SERVICE BULLETIN

Subject: Design Change to Harvest Assist Solenoid

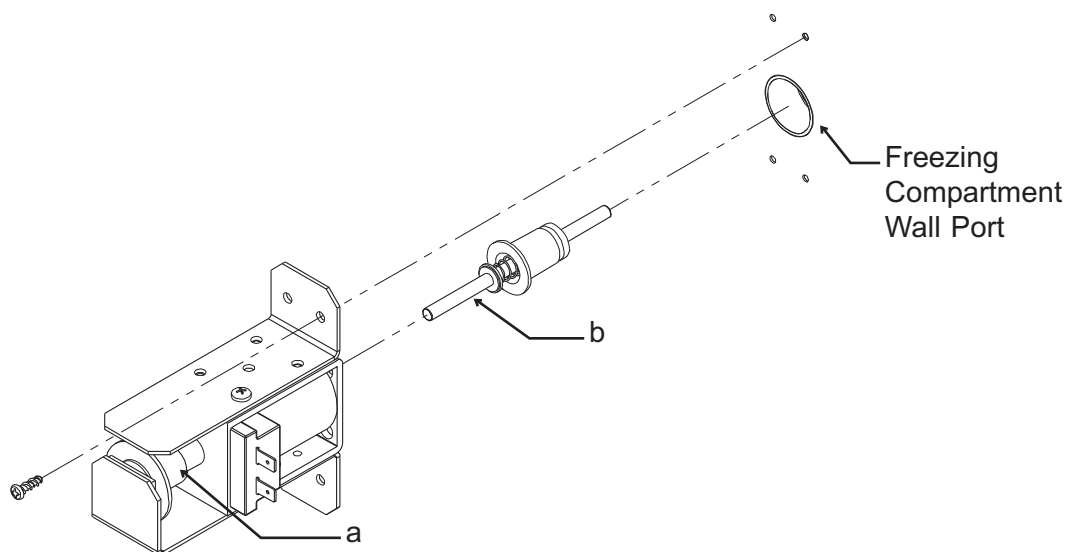
The design of the harvest assist solenoids has changed. The original design had a single push rod that extended from the solenoid coil, through the freezing compartment wall and into the back of a cube cell. The new design has a two part push rod. One part (a) is completely within the coil of the solenoid, the second part (b) is partially within the coil and from there extends through the wall of the freezing compartment and into the back of a cube cell. When power is applied to the coil a pushes b which applies pressure to the back of the ice.

The new Harvest Assist Solenoids are interchangeable with the prior version. The b rod assembly mounts in the freezing compartment port, and the a coil assembly slips over it and attaches to the wall the same way as the prior type. These are the **new part numbers** for the service kits:

115 volt models	230 volt models
C0322, C0522, C0330, C0530, C0630, CU1526, CU2026 and CU3030, EH130, EH330	12-3022-21	12-3022-22
C0830, C1030, C1448, C1848, C2148	-	12-3023-22
EH222, EH430	12-3023-21	-
